KAT Explosion Samples - 2nd round

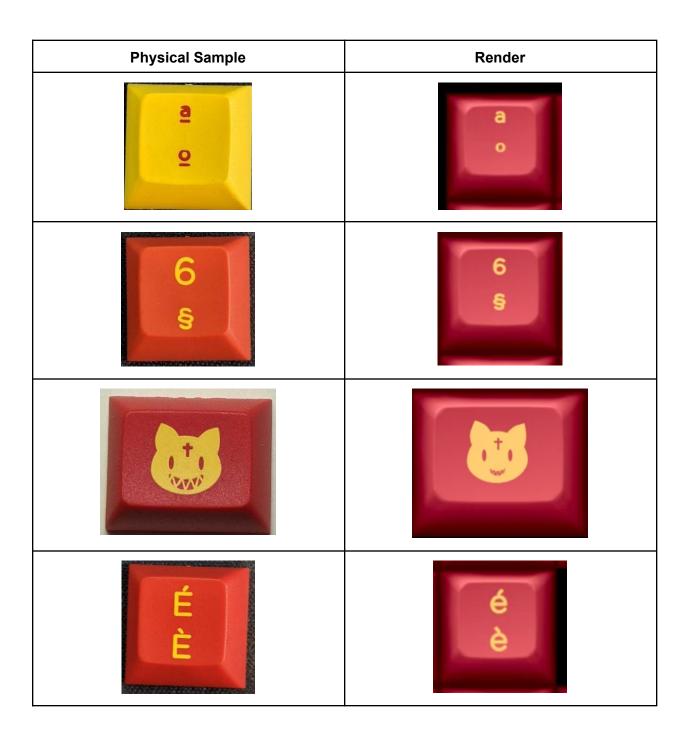
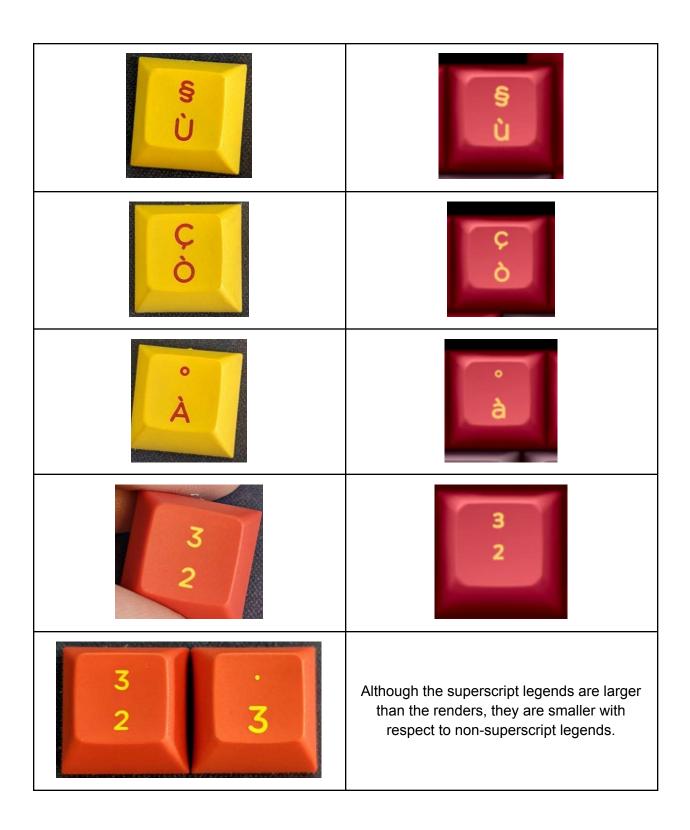
Please note that there are discrepancies in physical samples of legends with respect to legends on renders. These discrepancies are due to the limitations of doubleshot legends vs dyesub legends. These changes below have been accepted.

Underside plastic showing through the topside plastic

Inconsistent line thickness

Smudges/blemishes that are not removable

Issues being addressed with Keyreative:
